SITE 3  
FAIRLEE, EXIT # 15, I-91

STATEWIDE IM LITE (6)

TRAFFIC SHEET NO. 5 OF 37 SHEETS

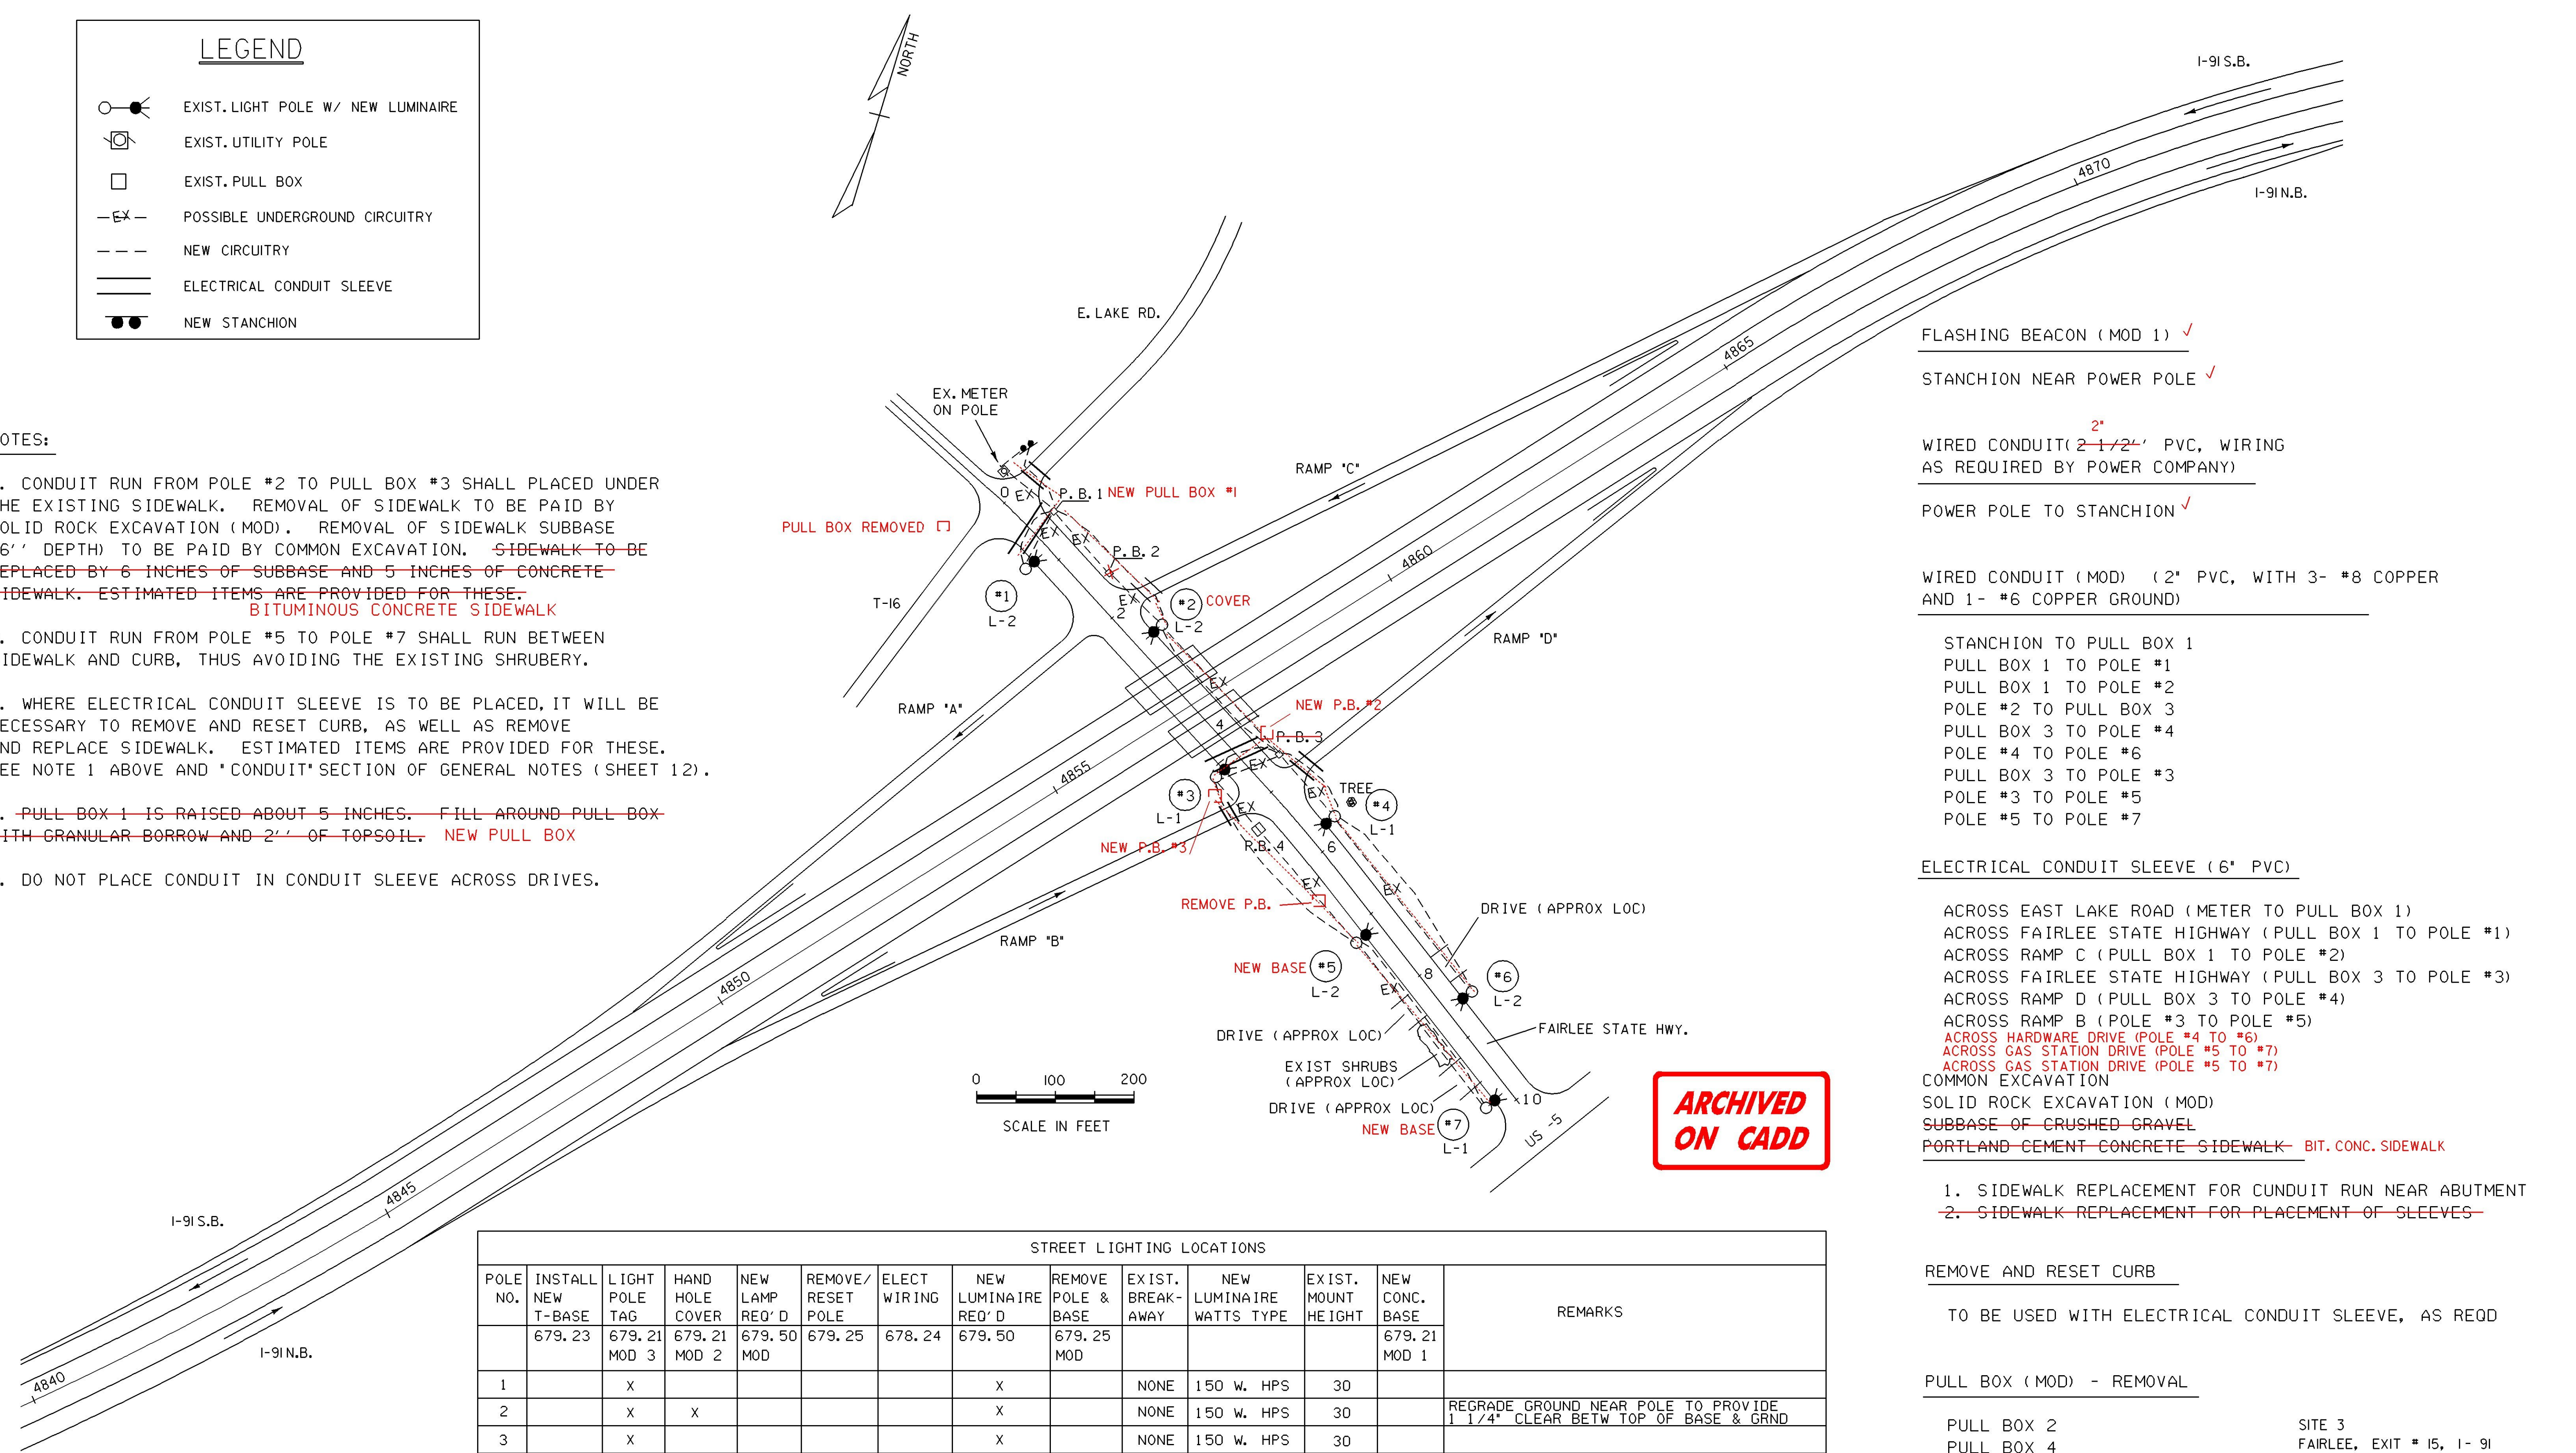
1. CONDUIT RUN FROM POLE #2 TO PULL BOX #3 SHALL BE PLACED UNDER THE EXISTING SIDEWALK. REMOVAL OF SIDEWALK TO BE PAID BY SOLID ROCK EXCAVATION (MOD). REMOVAL OF SIDEWALK SUBBASE (6' DEPTH) TO BE PAID BY COMMON EXCAVATION. ~~SIDEWALK TO BE REPLACED BY 6 INCHES OF SUBBASE AND 5 INCHES OF CONCRETE SIDEWALK. ESTIMATED ITEMS ARE PROVIDED FOR THESE.~~ **BITUMINOUS CONCRETE SIDEWALK**

4. ~~PULL BOX 1 IS RAISED ABOUT 5 INCHES. FILL AROUND PULL BOX WITH GRANULAR BORROW AND 2' OF TOPSOIL. NEW PULL BOX~~
5. DO NOT PLACE CONDUIT IN CONDUIT SLEEVE ACROSS DRIVES.
